Re: C15-2020-0003

CASE: C15-2020-0003

VARIANCE REQUEST: reduce minimum lot width from 50 ft. to 49.09 ft.

3409 NEAL STREET – BOA MEETING – ADDTL NOTES**Addendum to submittal regarding easement and reasoning per Karen Palacios comments on MCR for the sub case:**

3409 NEAL STREET
RESUBDIVISION OF EAST ONE-HALF
OF LOT 3, BLOCK A, CHERICO SUBDIVISION
TRAVIS COUNTY, TEXAS

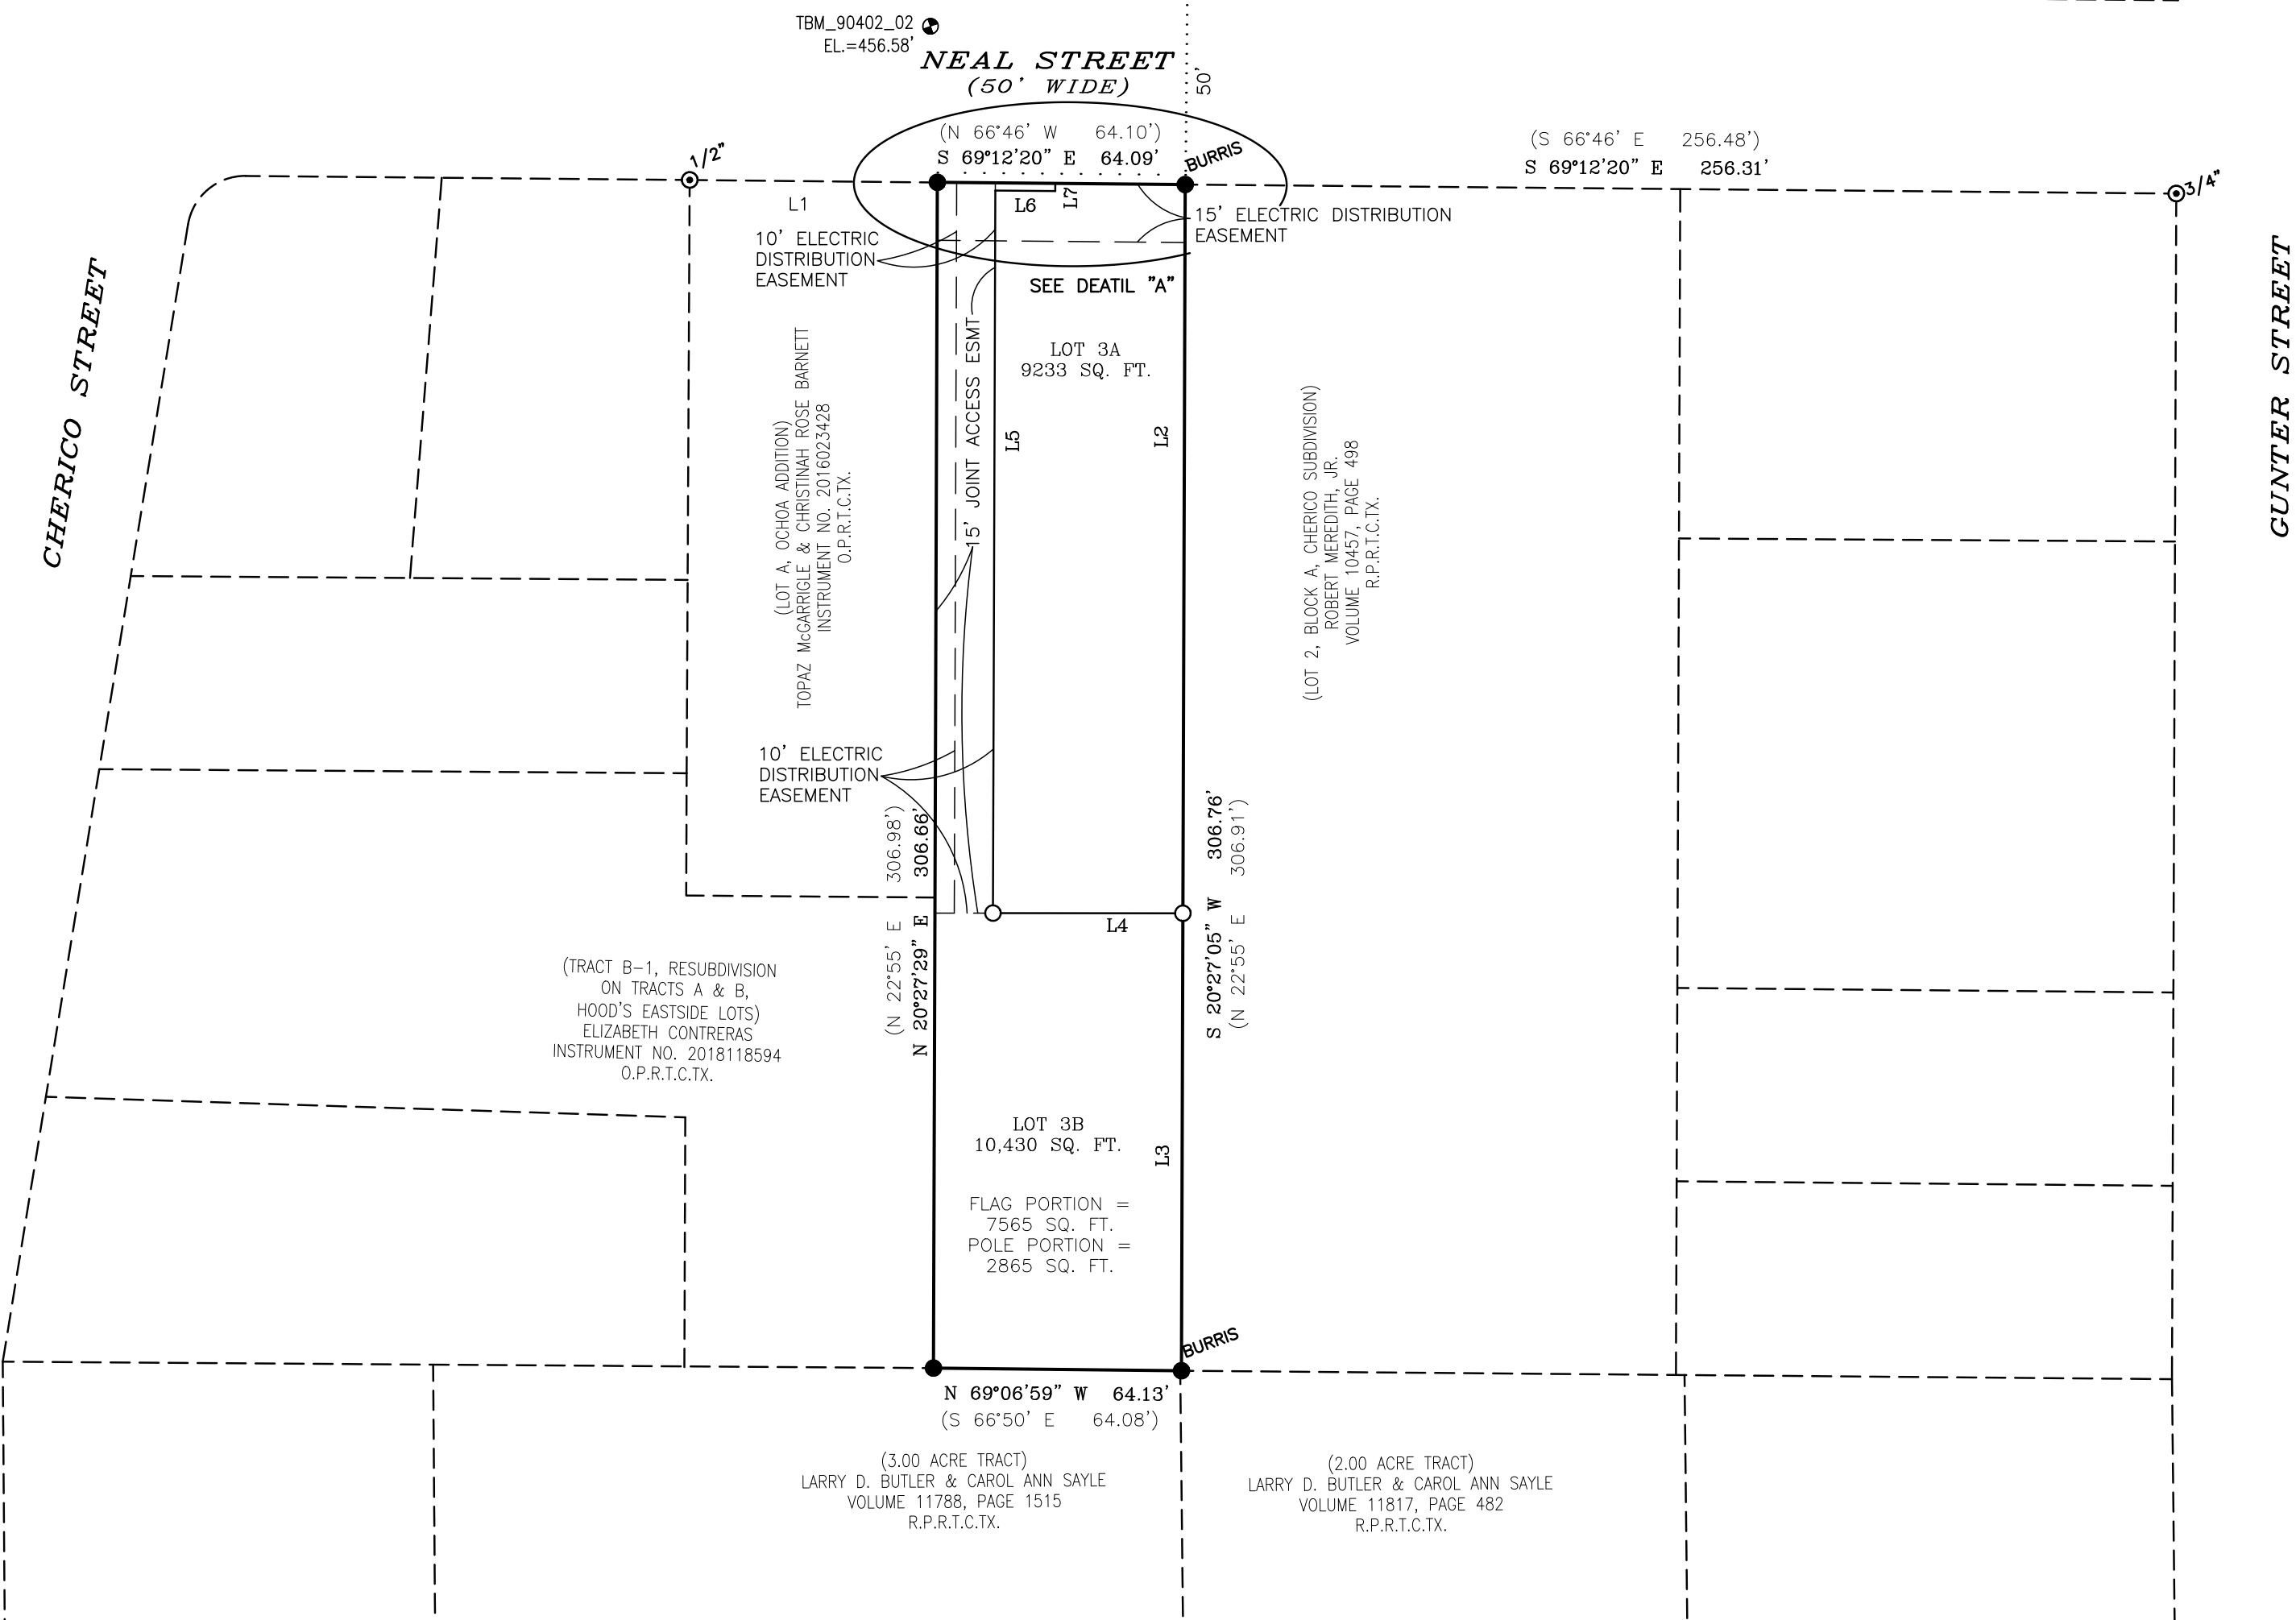
EL2. Provide a large sheet (24X36) of the driveway plan and profile plan. AW and AE do not share trenching. Provide utility assignments showing the electrical service to the back lot with a 10 ft. electrical easement and AW will need their own easement and provide AW's approval of separation from AE trenching. Plans are not readable.

UPDATE: Austin Energy service point at the ROW needs to be called out showing the meter location near the service point on private property. The shown UE needs to be clearly labeled as private electrical service. Be advised Austin Energy disconnect is located along the ROW. It's the applicant's responsibility for their private line extension. Comments stand.

UPDATE2: AE easement along the ROW cannot share with AW easement. The disconnect for the rear lot will be within the 15 ft. electrical easement along the ROW.

UPDATE3: On a phone call the applicant was to verify their disconnect will be along the ROW for the flag lot with their MEP. Electrical Easement within the development is shown for the flag lot and private W/WW are shown within it. Not allowed.

PERMIT PARTNERS/AERPARMIA RESPONSE: SEE ATTACHED REVISED PLAT AND UTILITY PLAN. PLEASE EMAIL EITHER MIA OR I DIRECT IF THERE ARE STILL CHANGES NEEDED ON THIS PLAN – MPARTON@AEPARMIA.COM OR JENNIFER@PERMIT-PARTNERS.COM

Per Bowman - according to her images, Karen thought the private w/ww lines were in the AE easement because of how the plat was drawn up. Editing it to show the 5' gap between the fence and the easement shows the lines are fine.

Aeparmia's drawings have shown AE's easement 5' offset from the property line. That gave the w/ww 5' of space to reach Lot B and not be in the AE easement. But since Karen was looking at the plat which showed the easement incorrectly along the property line, she assumed w/ww would be too close.

Bowman updating the plat shows now that that isn't the case, AE has their own easement where their distribution line will be by itself all the way to the back and there's still space for private w/ww lines to also reach Lot B as well.
